**Several figures in Chapter 13 of the March 2005 NOvA Proposal
have been revised as indicated in the text below.**

Subject: Error in NOvA Sensitivity Calculations

Figure 1

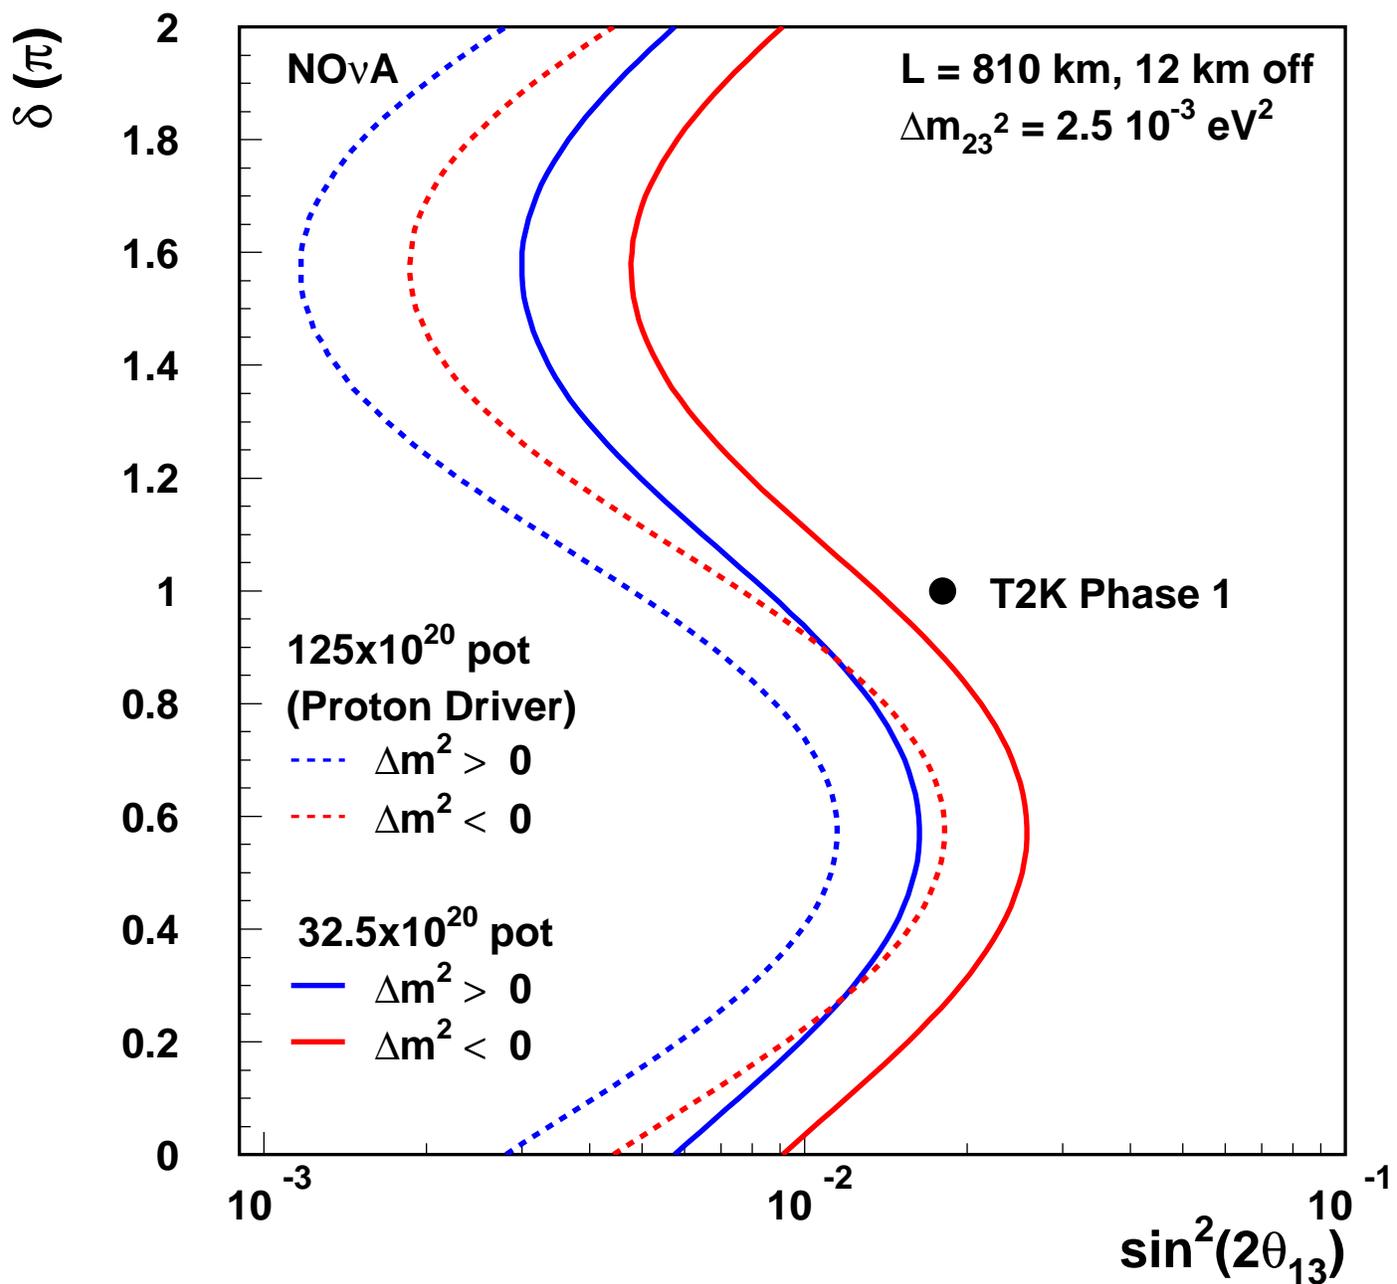
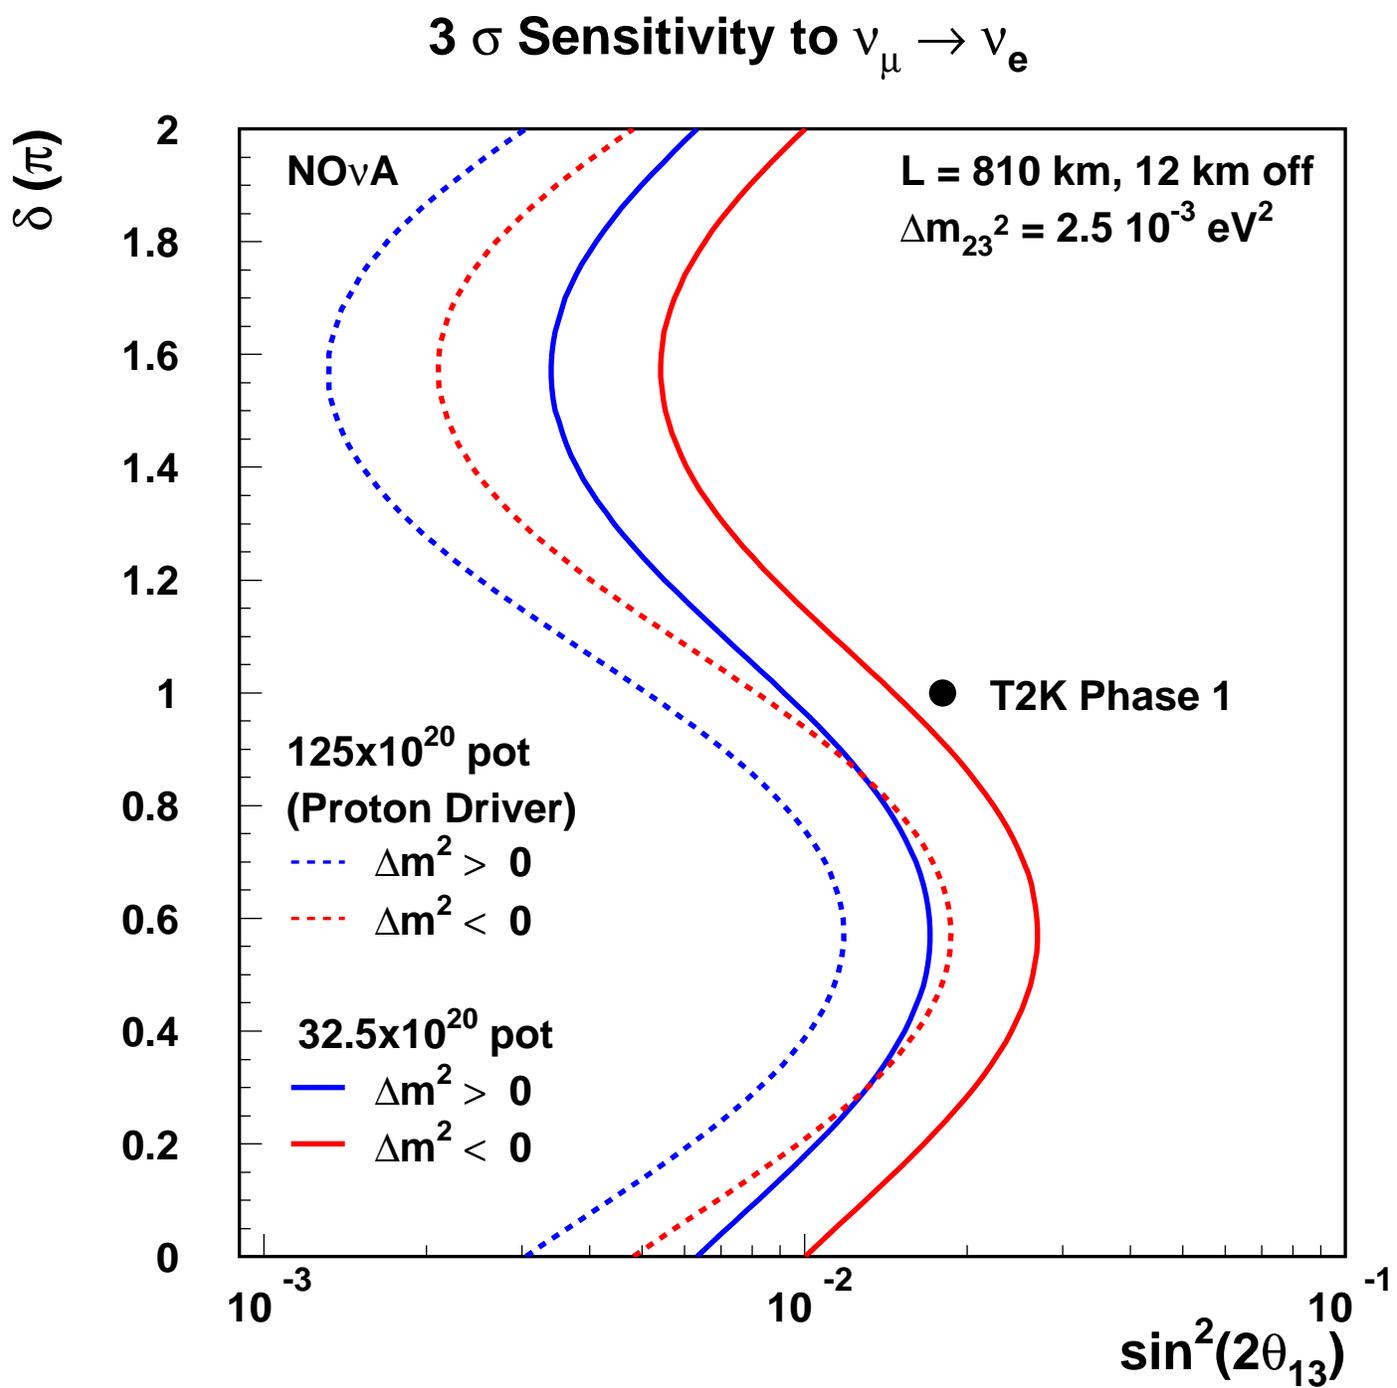
> The signal and background rates were calculated for a 25 kT
> detector. When we decided on a 30 kT detector, I increased the
> signal rates by 20%, but inadvertently failed to increase the
> background by the same ratio. Thus, the background was
> underestimated in my calculations by 0.65 events/year. The
> difference can be seen by comparing the attached Fig. 1, which is
> what I showed the PAC in April, to Fig. 2, which is the corrected
> figure. The sensitivity has decreased between 5 and 14% for the
> pre-PD curves and between 3 and 13% for the PD curves. The greatest
> decrease is for the region of delta for which we are most sensitive
> and the smallest decrease is for the region of delta for which we are
> least sensitive. In other words, the sensitivity curves become
> flatter with delta.

Figure 3

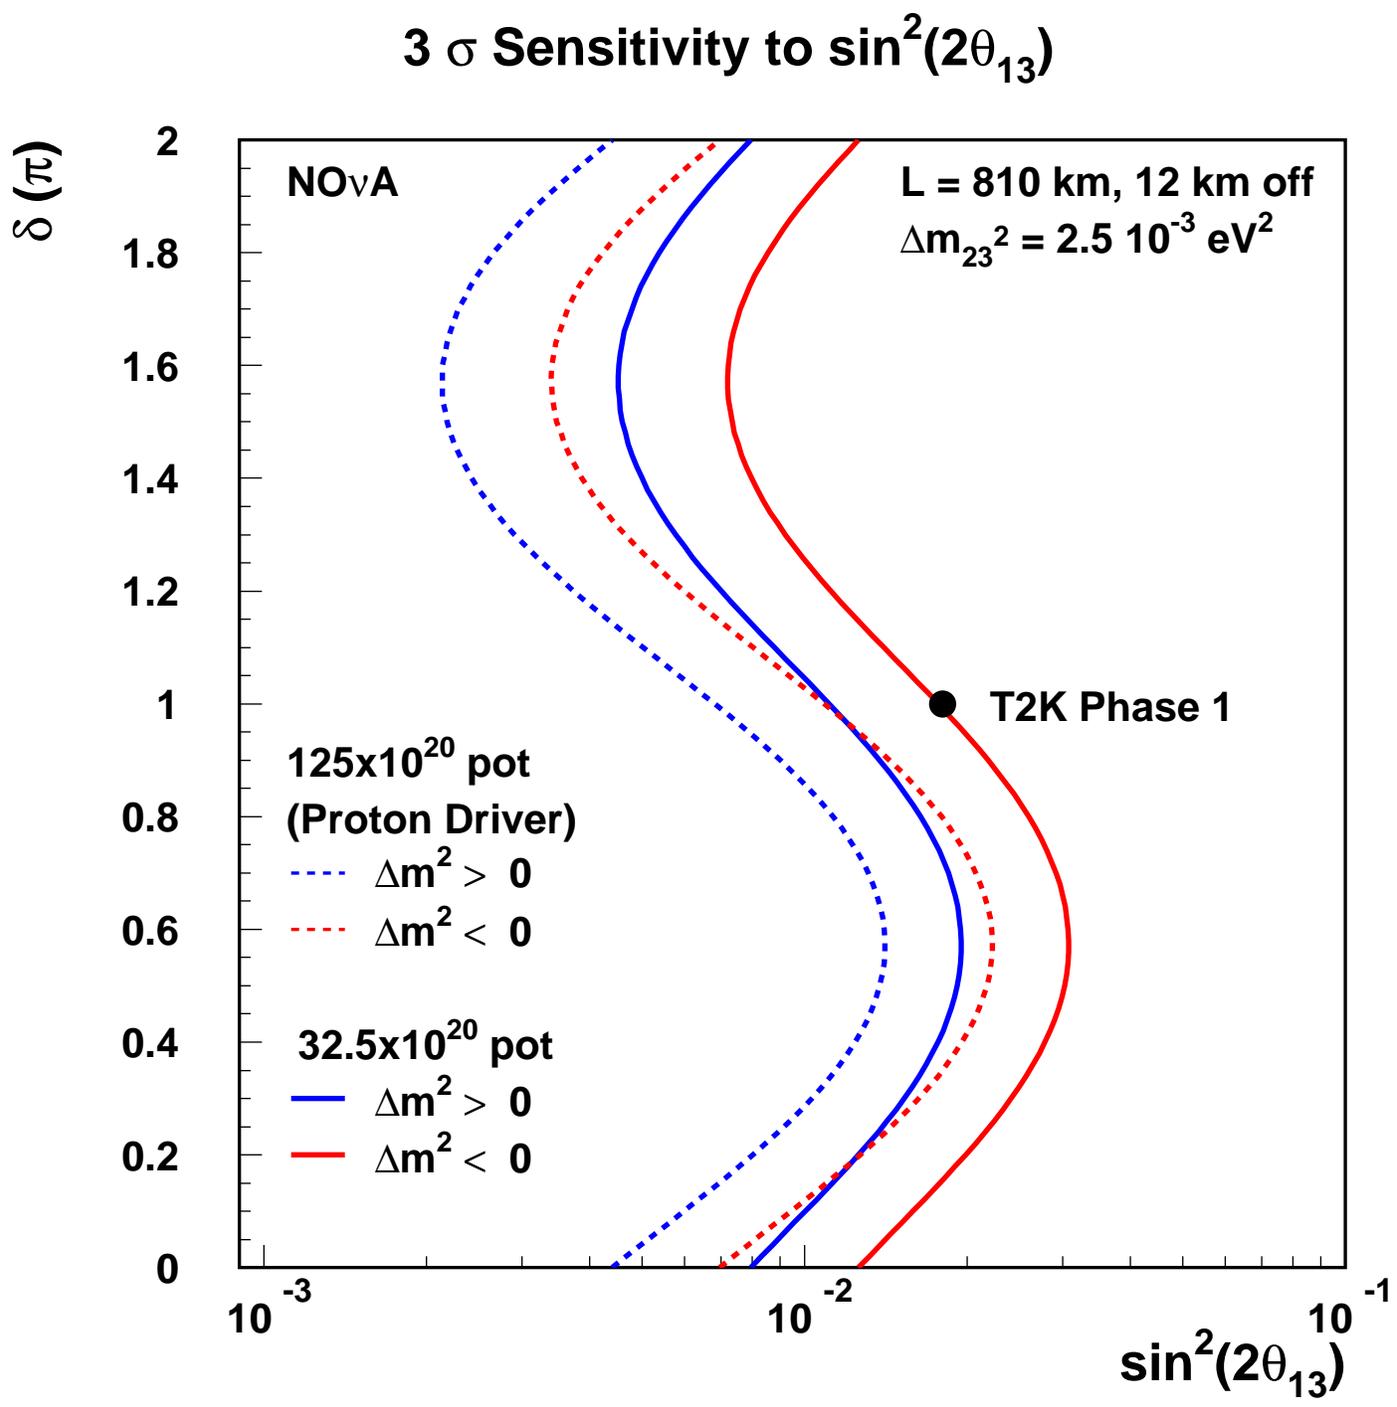
> the signal. Fig. 3 shows the sensitivity to $\sin^2(2\theta_{13})$. It
> differs from Fig. 2 by between 14 and 33% for the pre-PD curves and
> between 19 and 62% for the PD curves. Again, it tends to flatten the
> curves with delta. Given that this is what we are really interested
> in, I think that we should quote the sensitivity to $\sin^2(2\theta_{13})$ in
> the future.

Figure 4

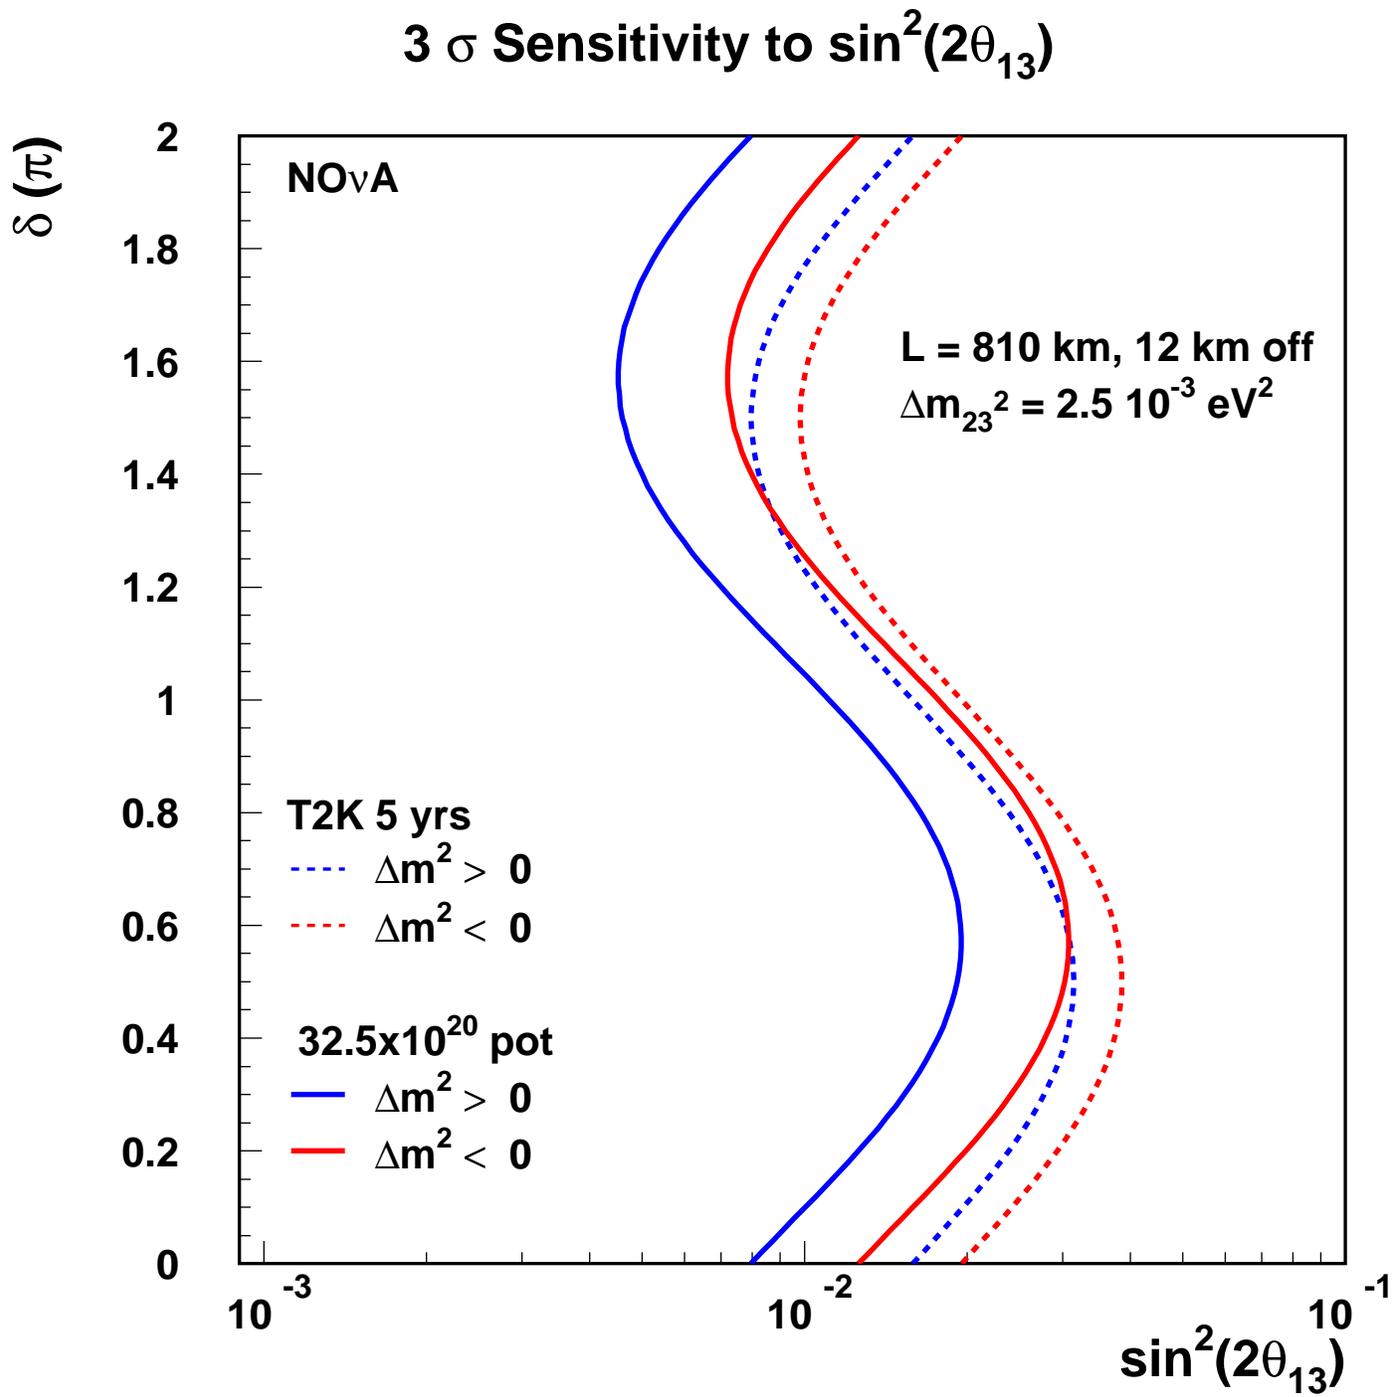
>
> This latter consideration does not significantly affect NOvA's
> relative sensitivity compared to that of T2K, since my calculation of
> their sensitivity will also become worse. This is shown in Fig. 4.
> The T2K sensitivity decreases between 11% and 25%. This decrease is
> smaller than that for NOvA simply because T2K is a less sensitive
> experiment. (My calculation for the average T2K sensitivity now
> agrees exactly with their public statements that it is
> $\sin^2(2\theta_{13}) > 0.018$. I think this is somewhat of an accident for
> at least three different reasons, which I will not go into here.)

Figure 5

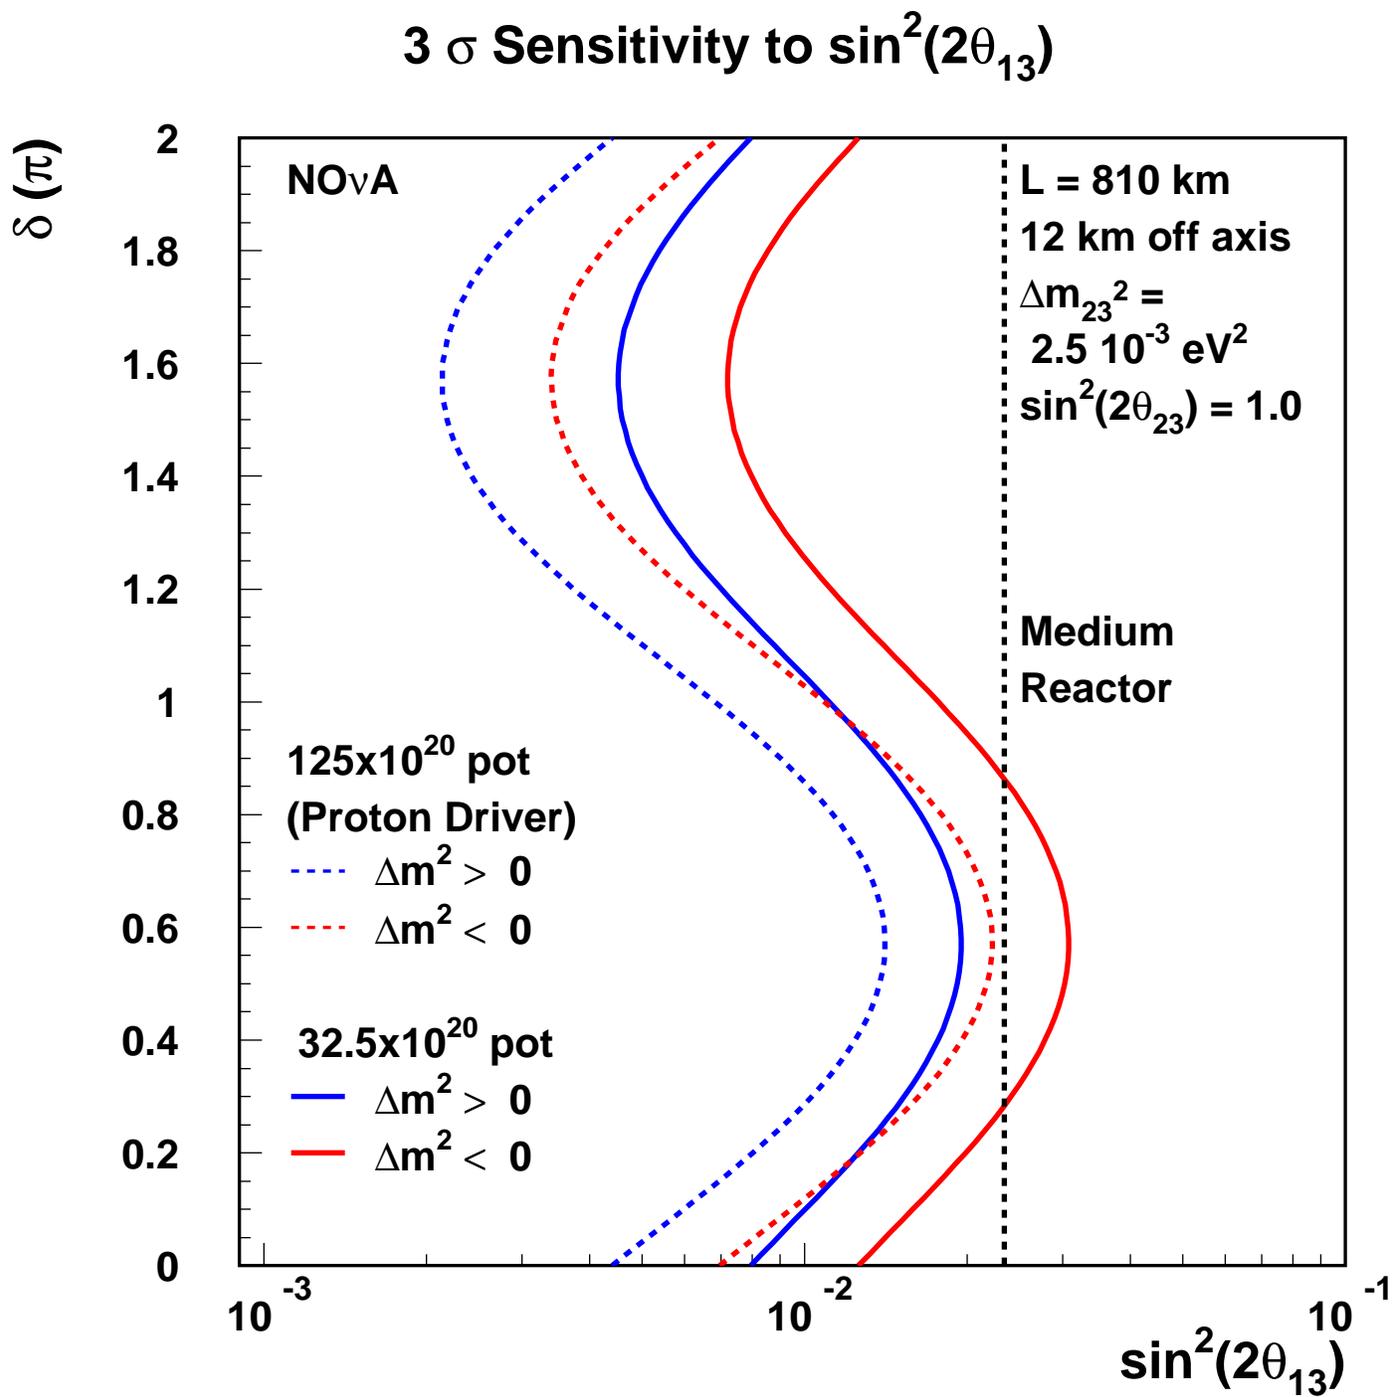
>
> Fig. 5 shows the comparison of NOvA with a "medium reactor"
> experiment. NOvA has better sensitivity for all delta values for the
> normal mass hierarchy and for 70% of delta values for the inverted
> mass hierarchy. Since, as far as I know, there is no theoretical
> prejudice in favor of any particular delta value, it would make some
> sense to adopt a run plan that maximizes the sensitivity for the
> least sensitive value of delta. This is shown in Fig. 6, which
> divides a five-year run equally between neutrinos and anti-neutrinos.
> Now, NOvA has substantially better sensitivity for all delta values.
